VERMONT AGENCY OF TRANSPORTATION			
	PROJECT NAME: BENNINGTON		
	PROJECT NUMBER: AC NH 019-1(52)		
	FILE NAME: ...\\plot-files\\zd307c2dp03.prf	PLOT DATE: 5/16/2011	
	DESIGN SUPERVISOR: GREG EDWARDS	DRAWN BY: STANTEC	
	DESIGNED BY: MARC FOISY	CHECKED BY: GARY SANTY	
	DRAINAGE PLAN DP-03	SHEET 83 OF 267

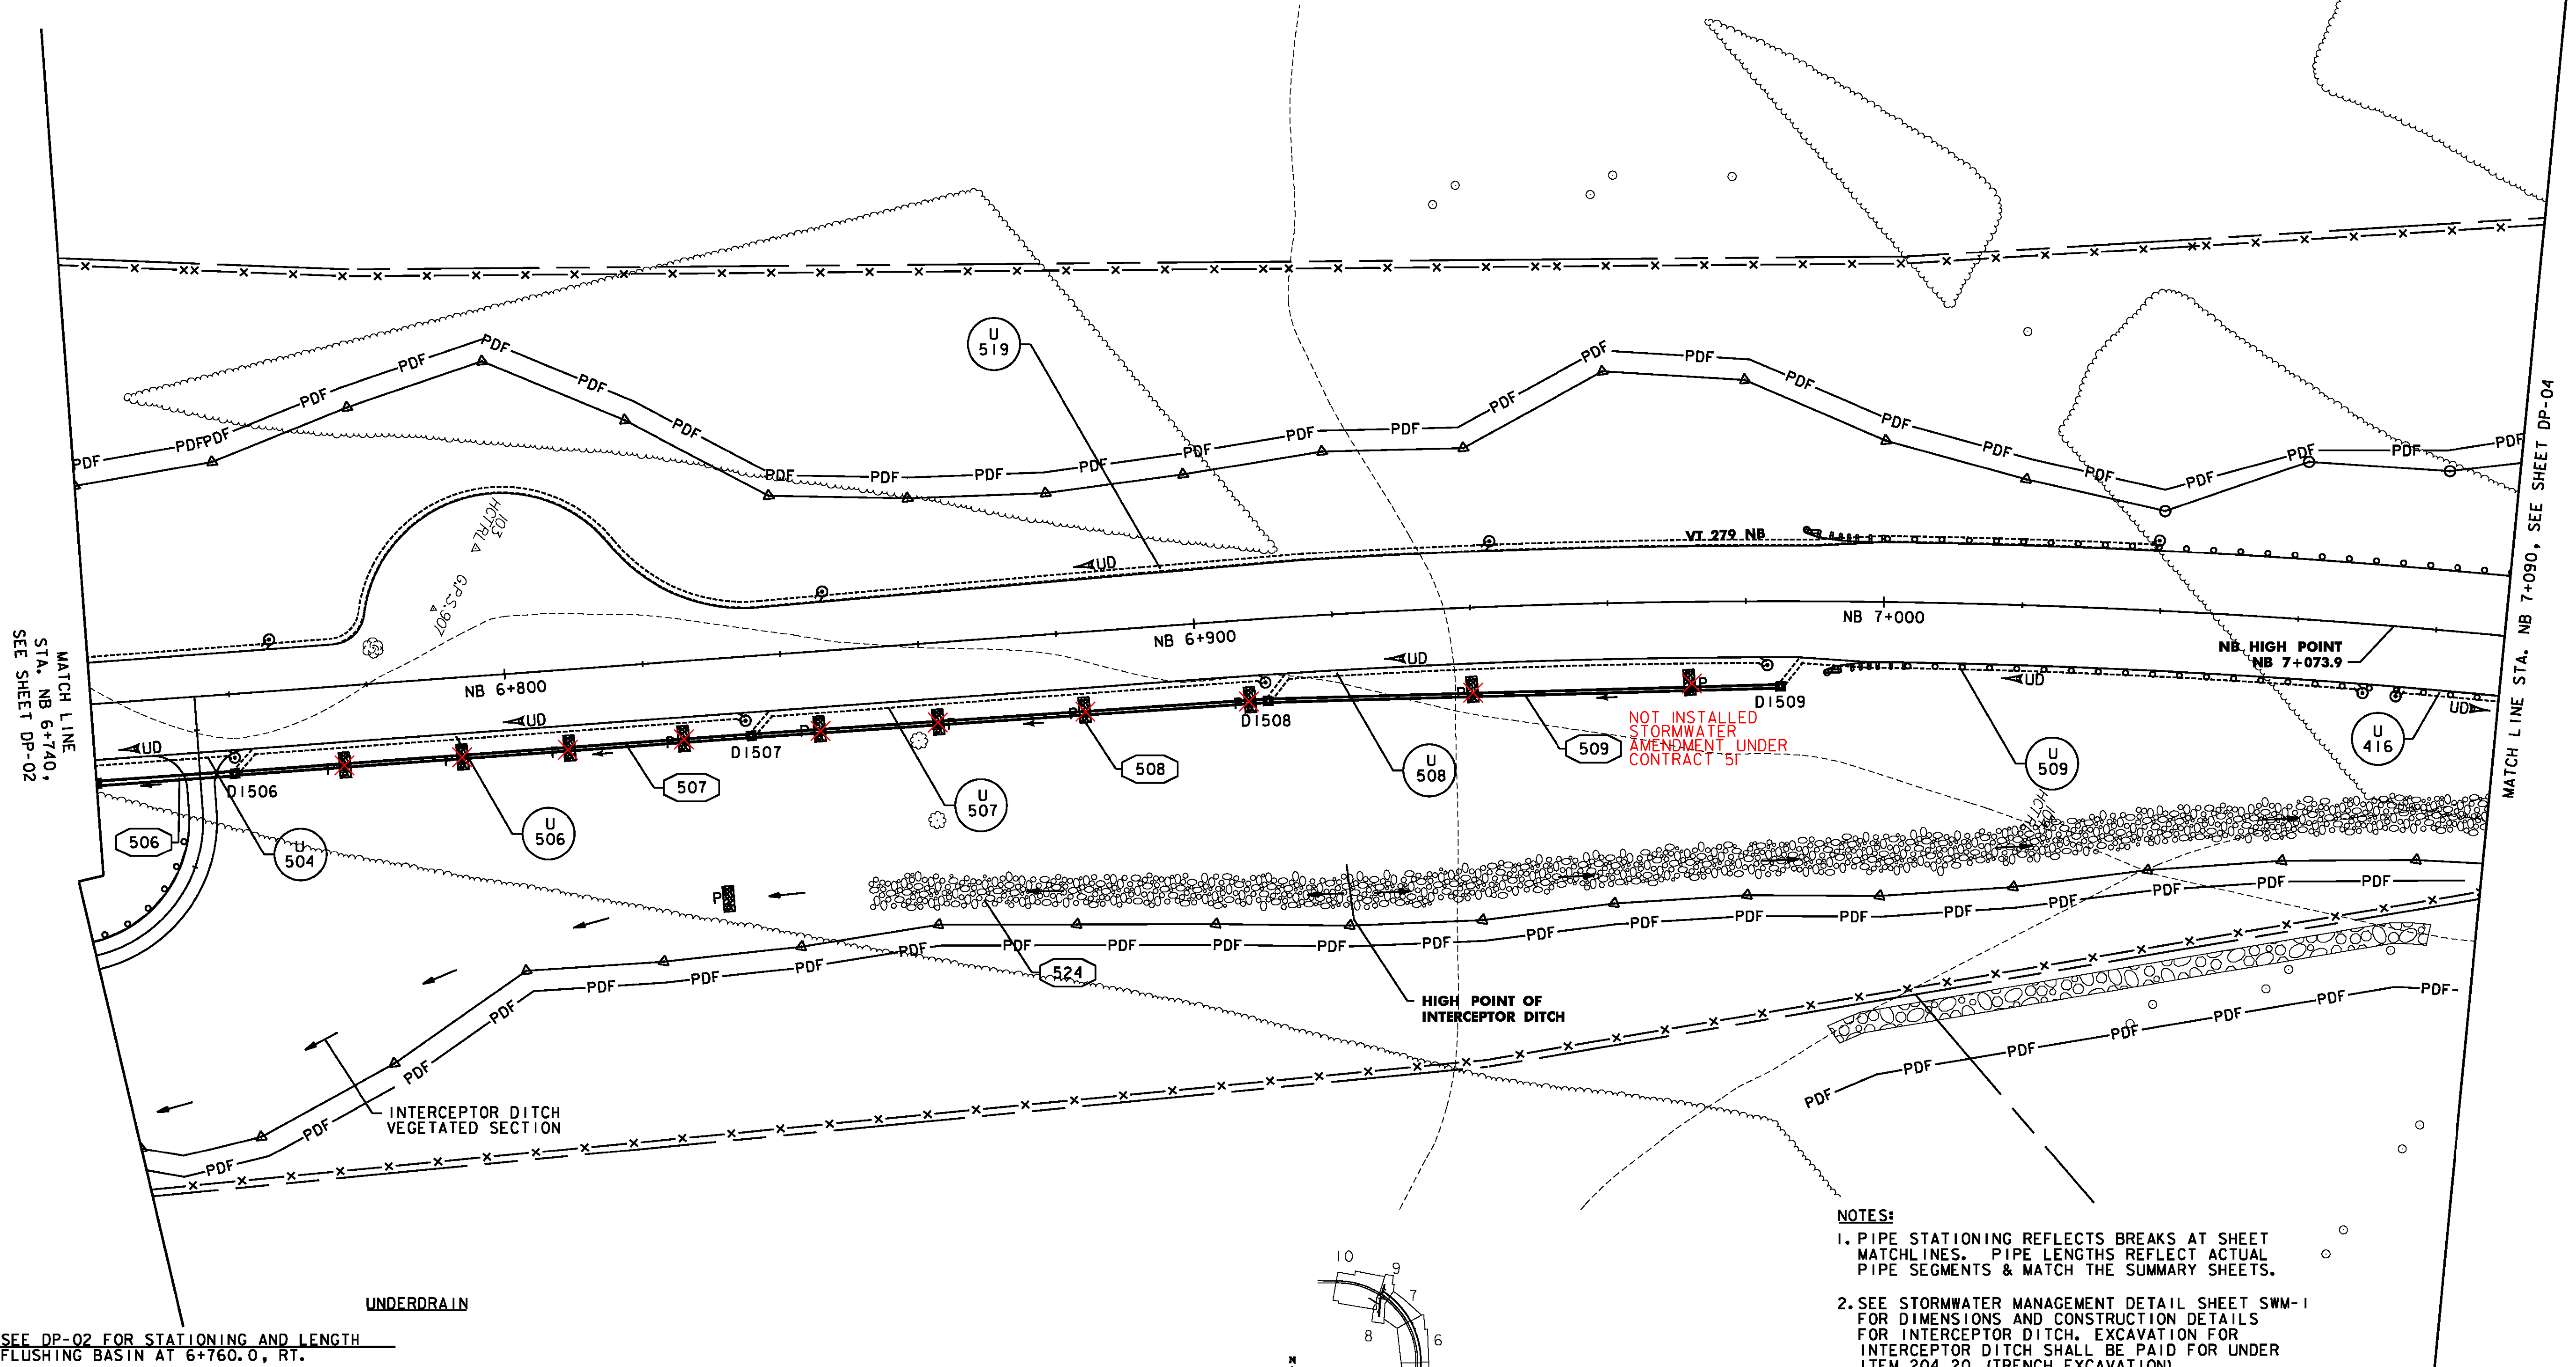
~~PERMANENT STONE CHECK DAMS, TYPE 1~~
~~STA. NB 6+775.161, 11.4m RT.~~ ~~STA. NB 6+970.930, 11.7m RT.~~
~~STA. NB 6+829.242, 34.8m RT.~~
